Attachment 5

Attachment 5: Referenced Reviewing Agency Comment Letters and Documents

B2HAPPDoc ApASC Exhibit N - IPC Responses to ODOE's RAI-4

**Idaho Power's Response to ODOE's Request for Additional Information 4
 Exhibit N – Need
 Boardman to Hemingway Transmission Line Project
 January 2018**

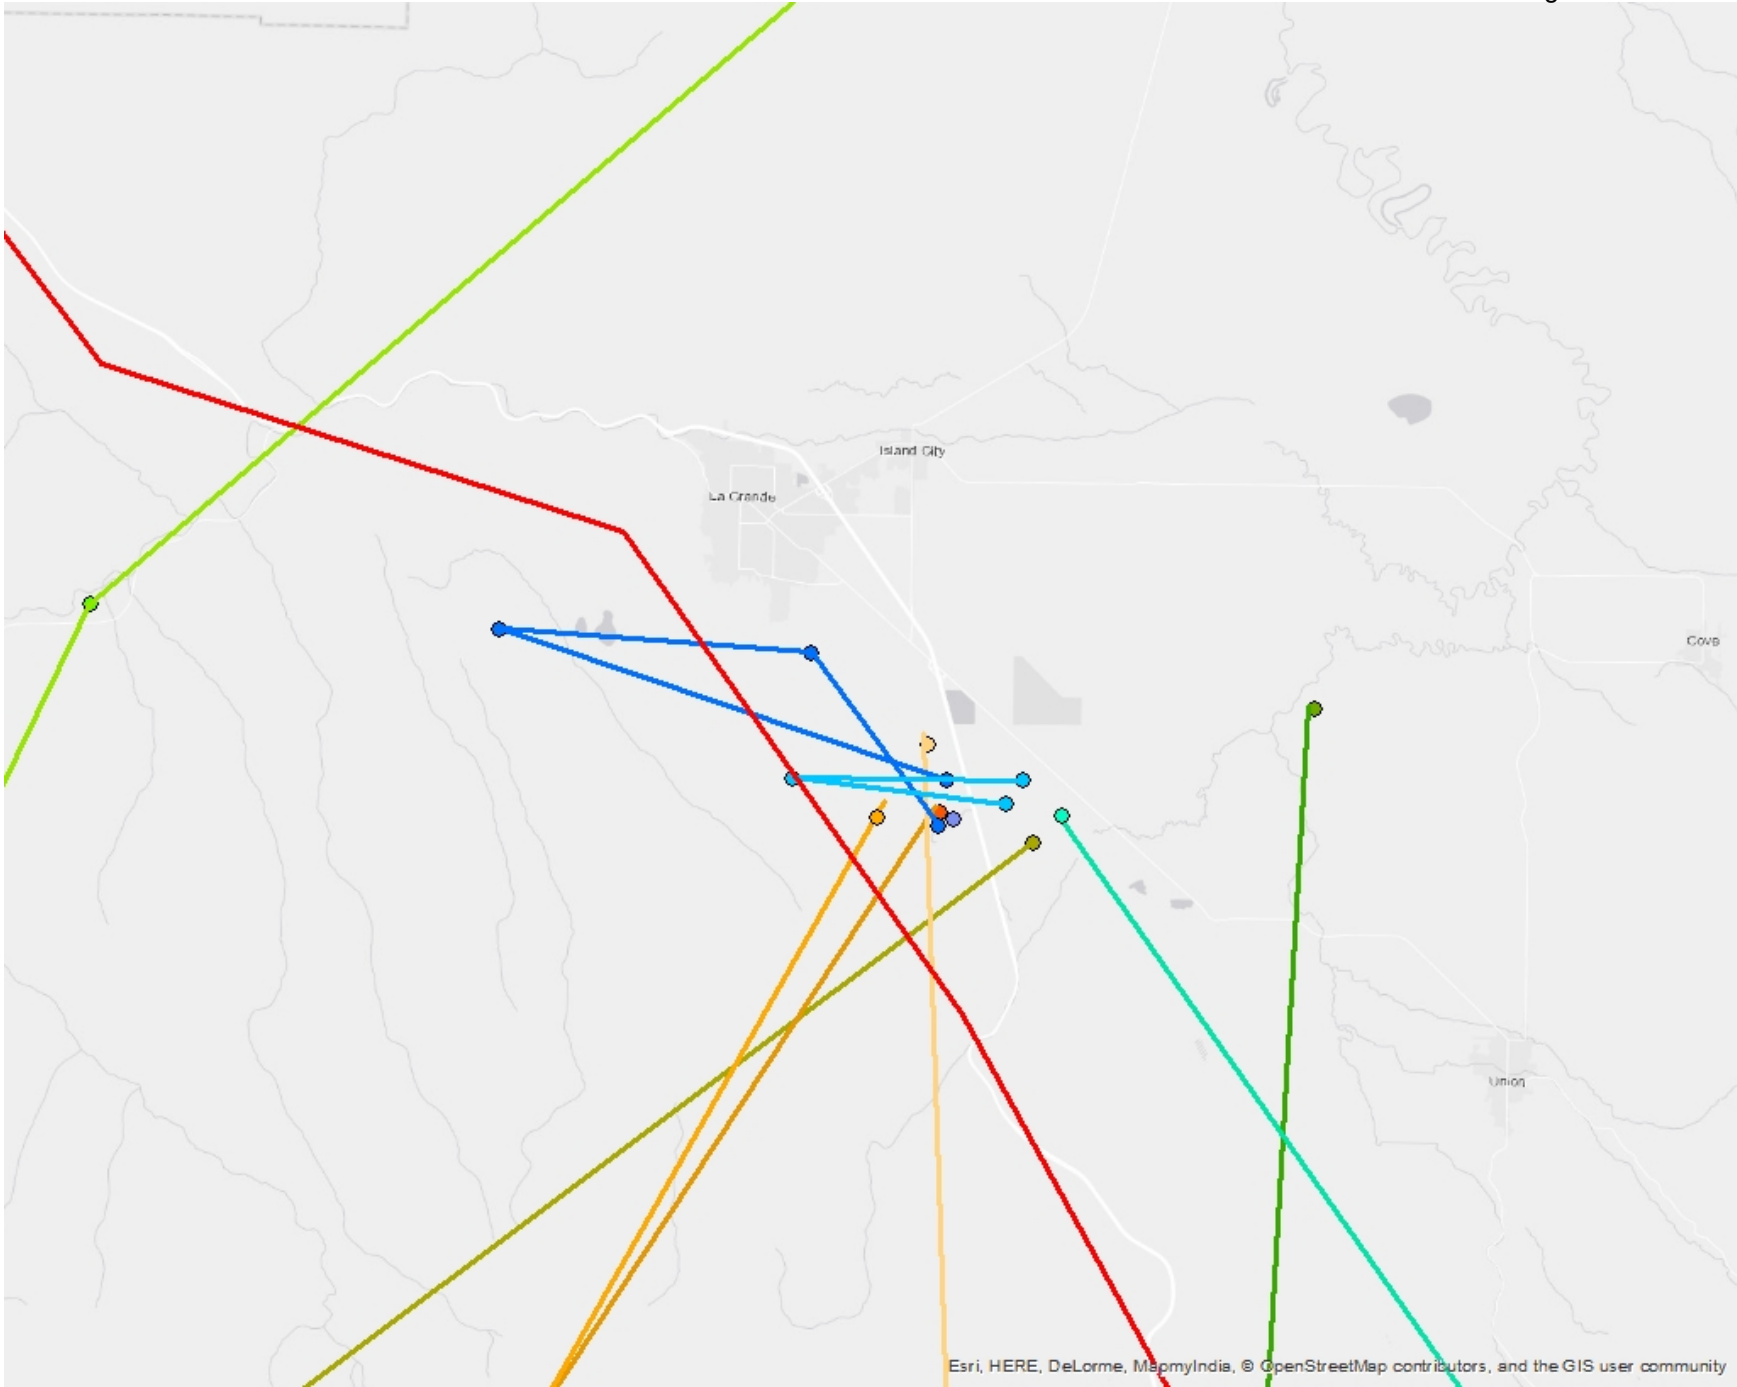
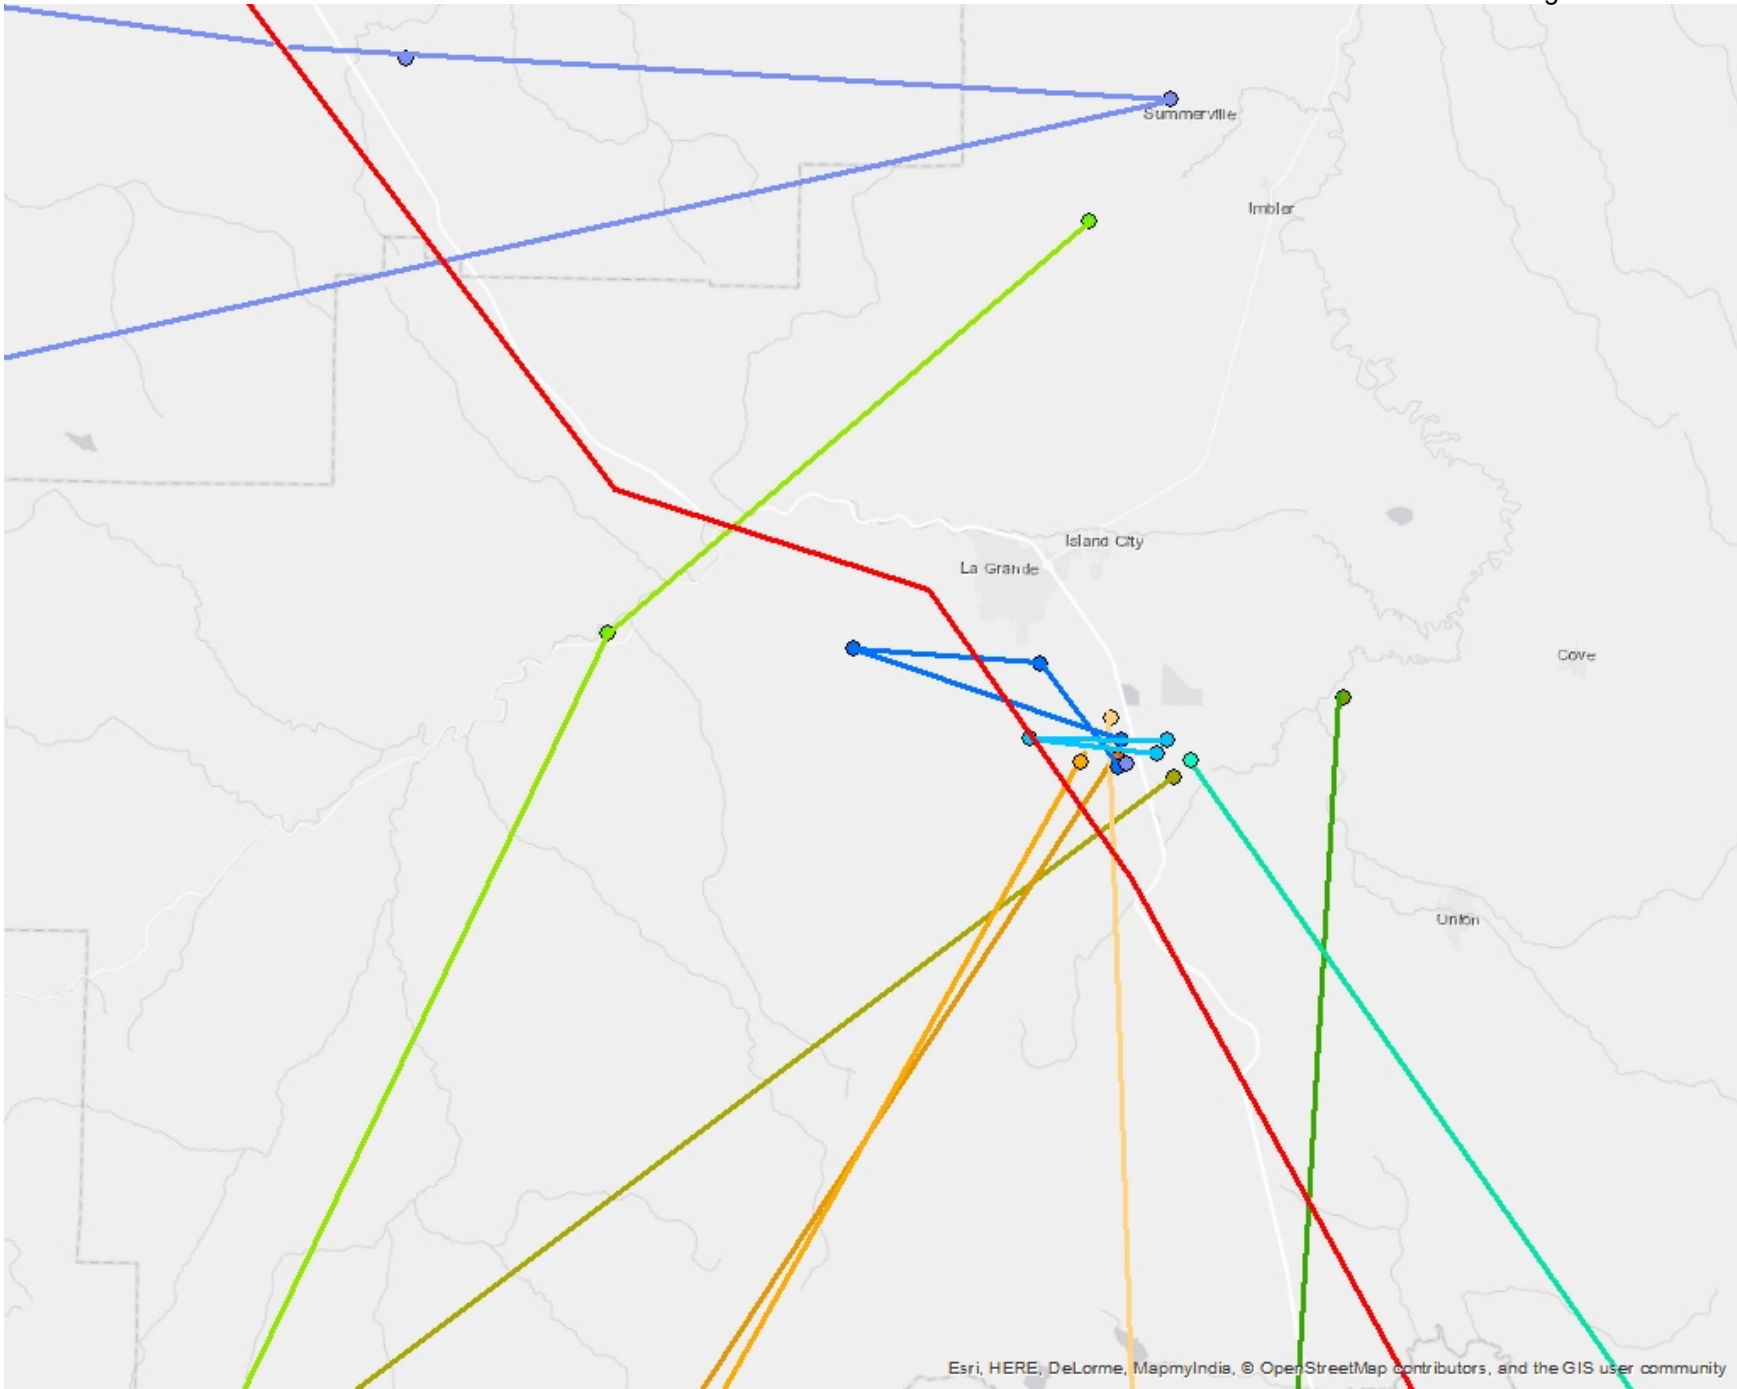
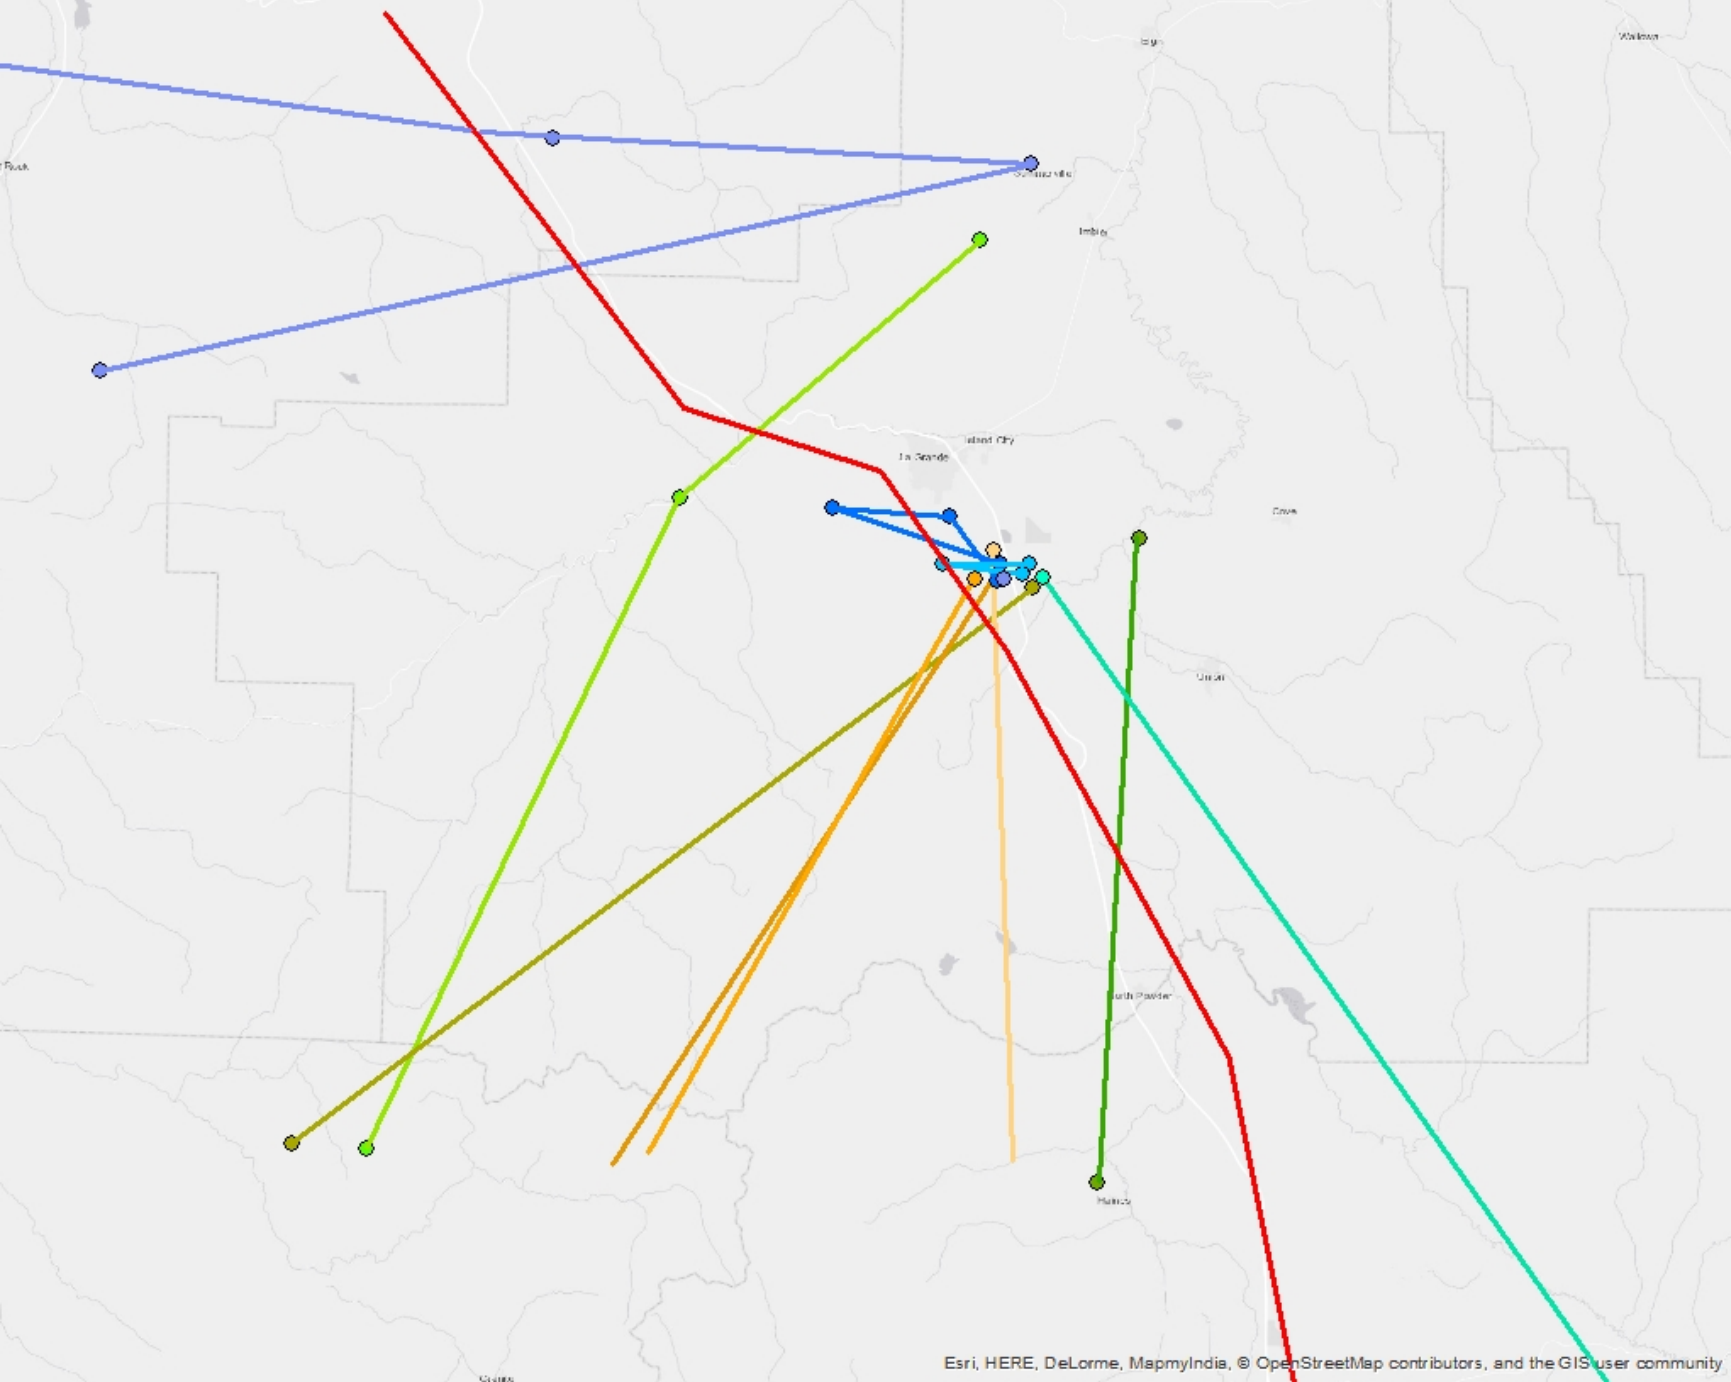
Given a high level of concern regarding sandhill crane mortality due to collisions with transmission power lines (Birds of North America Online), I believe these data support a request for mitigation measures, in the form of UV lights on the lines, along the B2H transmission line from central Baker County to the Umatilla County line.

If more detailed data are useful, I do have the raw telemetry data for numerous migrations by several sandhill cranes.
